Access Compliance Report Public Rights-of-Way (Curb Ramps)

Main Street: SCARLET_MAPLE_DR Cross Street: SMOKE_TREE_DR Location: NE

ADA ID: RPAT211102153308 Ramp Type: Type 4 - Parallel Initial Pass/Fail: Fail Overall Compliance: No Severity Score: 32

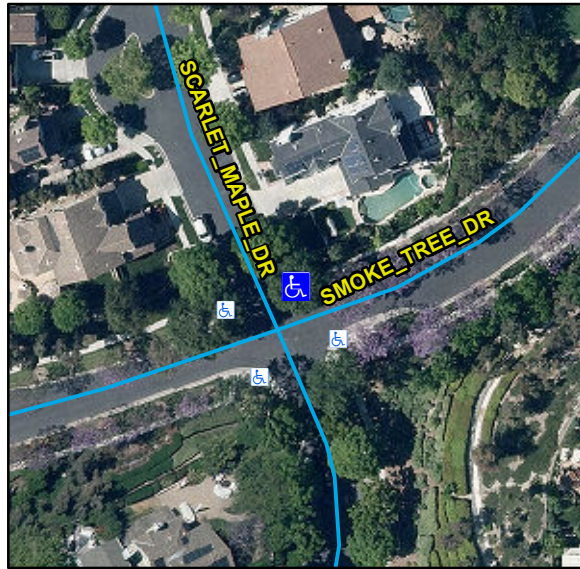
Compliance	Description	Data	Compliance	Description	Data
N/A	Ramp Length LT (in)	110	N/A	Ramp Length RT (in)	105
Yes	Ramp Width LT (in)	54	Yes	Ramp Width RT (in)	54
Yes	Ramp Run Slope LT (%)	4.5	No	Ramp Run Slope RT (%)	18
No	Ramp Cross Slope LT (%)	3.5	No	Ramp Cross Slope RT (%)	2.4
N/A	Landing Present	N/A	N/A	DWS Provided	N/A
N/A	Landing Length (in)	N/A	N/A	DWS Contrast	N/A
N/A	Landing Width (in)	N/A	N/A	DWS Length (in)	N/A
N/A	Landing Run Slope (%)	N/A	N/A	DWS Full Width	N/A
N/A	Landing Cross Slope (%)	N/A		DWS Offset Type	N/A
N/A	Landing Movement Obstructed?	N/A	N/A	DWS Offset Left (in)	N/A
	Landing Movement Type	N/A	N/A	DWS Offset Right (in)	N/A
N/A	Landing Shared	N/A			
N/A	Clear Space	Yes			
N/A	Clear Space To Crosswalk (in)	N/A			
N/A	Marked Crosswalk 1	No	N/A	Marked Crosswalk 2	No
	Crossing 1 Direction	W		Crossing 2 Direction	S
	Marked Crosswalk 1 Width (in)	N/A		Marked Crosswalk 2 Width (in)	N/A
N/A	Ramp Inside Crosswalk 1	N/A	N/A	Ramp Inside Crosswalk 2	N/A

Remove & Replace Curb Ramp With Two New Directional Ramps or Equivalent.
